## COMMERCIAL CHECKLIST

FILE NAME: E.C.O. Elwin Orydone

APPLICANT: Dammon Engineering (Chuck Dammon)

DATE: March 20, 2007

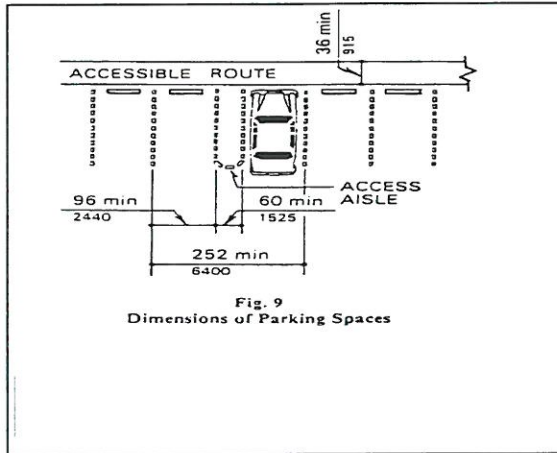
✓ COMMENTS: **Please show measurements of front parking spaces.**
